**BOARD OF ZONING ADJUSTMENT  
STAFF REPORT****Date: October 6, 2014****CASE NUMBER**

5919/5866

New Cingular Wireless PCS, LLC

**LOCATION**6311 Cottage Hill Road  
(220'± South of Cottage Hill Road, 780'± East of Hillcrest Road)**VARIANCE REQUEST****HEIGHT:** Height Variance to allow a 150' monopole telecommunications tower in a B-2, Neighborhood Business District.**SETBACK:** Setback Variance to allow the tower within 37.5' of the lease parcel line.**RESIDENTIAL BUFFER SEPARATION:** Residential Buffer Separation Variance to allow the tower within 42.75' of residentially zoned property.**TREE PLANTING:** Tree Planting Variance to allow no tree plantings.**ZONING ORDINANCE  
REQUIREMENT****HEIGHT:** The Zoning Ordinance limits structures to a 45' height in a B-2, Neighborhood Business District.**SETBACK:** The Zoning Ordinance requires telecommunications towers to be setback the height of the tower (150') from the lease parcel line.**RESIDENTIAL BUFFER SEPARATION:** The Zoning Ordinance requires a residential buffer separation of 200' or 150% of the height of the tower, whichever is greater (225').**TREE PLANTING:** The Zoning Ordinance requires one tree per every 30' of lease pa

# DETAIL SITE PLAN

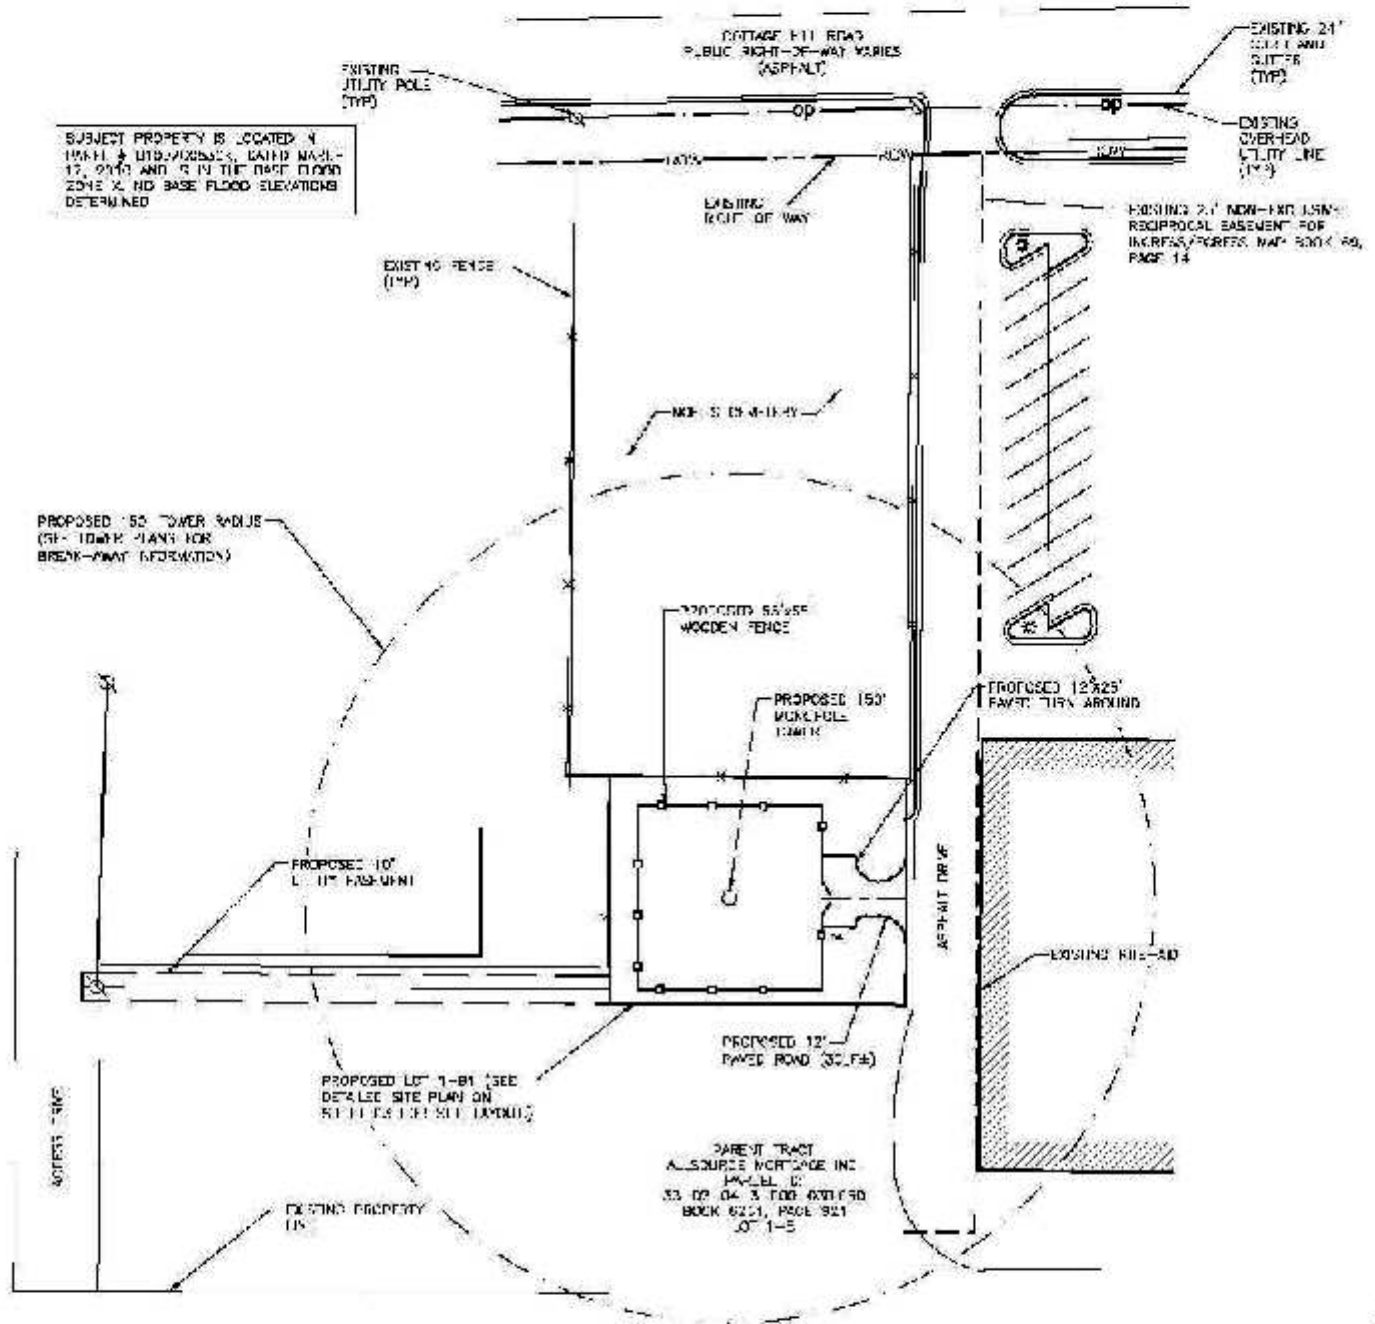
With regard to the Setback and Residential Buffer requests, the applicant states that the requirement to meet the Zoning Ordinance provisions for setbacks and residential buffer present a specific unnecessary hardship due to the constraints of the small parcel. It is stated that neither of these hardships is economic in nature or self-imposed by the applicant and it is believed that the proposal to place the proposed tower within a wooded area on the property best serves the need to provide the least visually obtrusive alternative. As the site is limited in area by surrounding properties, a hardship is illustrated in meeting the required lease parcel setbacks and the Setback Variance request would be justified. And as the technical data submitted supports the selection of this location for the proposed tower, and as a hardship in meeting the Residential Buffer Separation requirement is imposed by the site's location, the Residential Buffer Separation Variance would be justified. Although the closest residentially-zoned property is a cemetery approximately 43' North of the proposed tower, a single-family residential subdivision is located approximately 145' South of the proposed tower. Due to the proximity of the residential property to the South, the applicant has proposed a 6' wooden privacy fence around the tower compound. However, the site plan should be revised to indicate an 8' high fence as required by the Chart of Permitted Uses of the Zoning Ordinance.

The site plan submitted indicates a contiguous hedge of evergreen shrubs around the tower compound and eight overstory trees beyond. However, the three trees indicated to the South of the compound are actually indicated to be on the adjacent separate proposed lot to the South. Therefore, only five overstory trees are indicated as actually proposed on the tower site, and the lot perimeter would require twelve overstory trees. The applicant bases the Tree Planting Variance request based on the proposed site mostly being surrounded by existing mature trees. However, some trees would have to be removed to develop the tower site and no hardship has been illustrated to justify the granting of the Tree Planting Variance request, especially in light of the fact that sufficient area would be provided by the clearing for the tower lease parcel to provide the required number of trees.

- 1) the tower is limited to a monopole design with an over-all height of 150', including the antenna extension and the lightning rod;
- 2) revision of the tower elevation to indicate that no communications equipment or lightning rod extends above the 150' elevation above grade;
- 3) revision of the site plan to indicate an 8' high wooden privacy fence around the tower compound as required by the Chart of Permitted Uses of the Zoning Ordinance;
- 4) provision of further overstory trees within the lot perimeter to be coordinated with the Planning Division of the Urban Development Department;
- 5) subject to the Planning Commission approval of the Planning Approval and two-lot Subdivision applications; and
- 6) full compliance with all municipal codes and ordinances.
